PLAN SNAPSHOT REPORT DSIAPP-000338-2026 FOR CITY OF SAINT PAUL

Plan Type: DSI Appeals

Description: An appeal of a appeal of a decision by the Board of Zoning Appeals denying two variances from the design standards of City Council Resolution 23-1442 for a development project at United Village Block D, where new commercial buildings facing arterial streets such as University Avenue are required to provide window and door openings comprising at least 50% of the ground-floor façade length and 30% of the ground-floor façade area, and the proposed hotel's north façade includes 43.1% of the façade length and 23.3% of the façade area as window and door openings, for variances of 6.9% and 6.7%

Zoning Variance Application United Village Block D (Hotel)

② NORTH ELEVATION - VARIANCE DIAGRAM
1/16" = 1'-0"

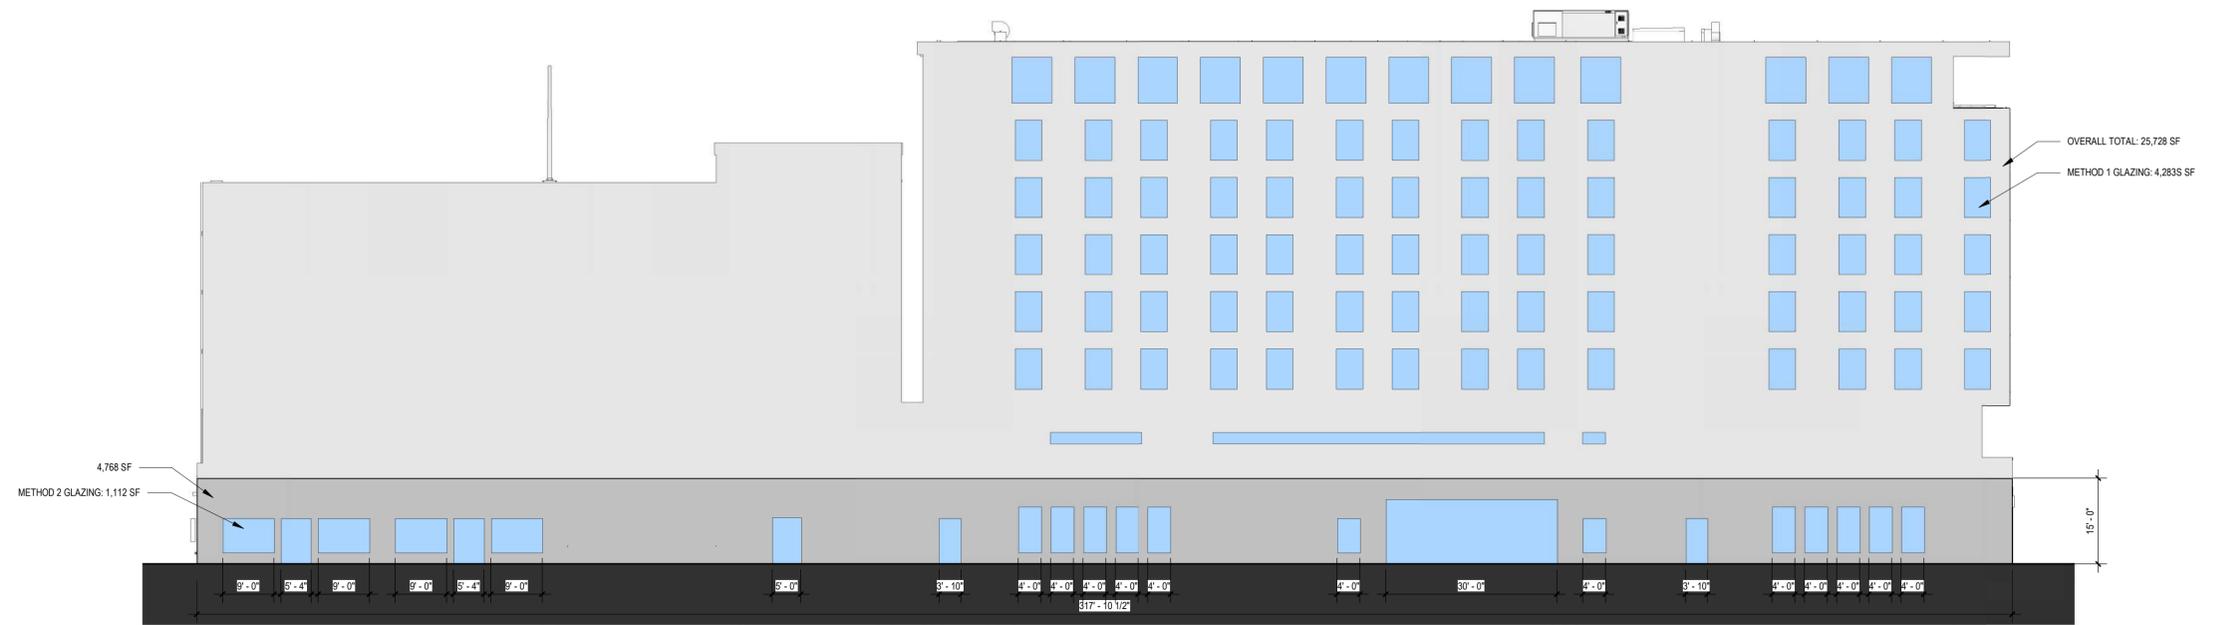
The window and door openings standards are intended to create active, visually engaging street frontages that enhance the pedestrian environment. The proposed north façade concentrates window and door openings at public areas such as the entrance, lobby, and retail spaces, while service and operational functions occupy portions of the façade that do not support pedestrian interaction. Though the proposal provides less window and door openings than required, the façade continues to support pedestrian engagement along University Avenue. Given the modest scale of the variances, the proposal remains consistent with the purpose and intent of the zoning code.

There are practical difficulties for a hotel in complying with the City Council Resolution's standard for ground floor window and door openings along all street facades. The applicant's narrative describes characteristics inherent to all hotels including ground level restrooms, back-of-house operations, and service areas in addition to common public areas including a lobby and amenities. In the operation of a hotel, the main patron spaces are more centrally located around the lobby. The proposed north façade of the hotel provides window

and door openings at public areas including the entrance, lobby, amenity and retail spaces, while restrooms, service and operational functions like elevators and stairwells occupy portions of the façade that are impractical for additional window or door openings.

The property will be used in a reasonable manner as a hotel with the proposed façade design. The standards for window and door openings are intended to create active, visually engaging street frontages that enhance the pedestrian environment. To supplement the window and door openings in the public areas of the hotel, the applicant's intent is to include a mural on the ground level wall of the restrooms adjacent to the retail shops where openings are impractical to enhance the pedestrian environment, as shown on the building renderings.

- F. **DISTRICT COUNCIL RECOMMENDATION:** Staff received a recommendation of approval from District 13 – Union Park District Council.
- G. **CORRESPONDENCE:** Staff have received a letter from Midway Chamber of Commerce in favor regarding these requests.
- H. **STAFF RECOMMENDATION:** Based on Findings 1 through 6, staff recommends approval of the requested variances to allow 43.1% length of openings and 23.3% area of openings on the ground floor of the building's north façade.
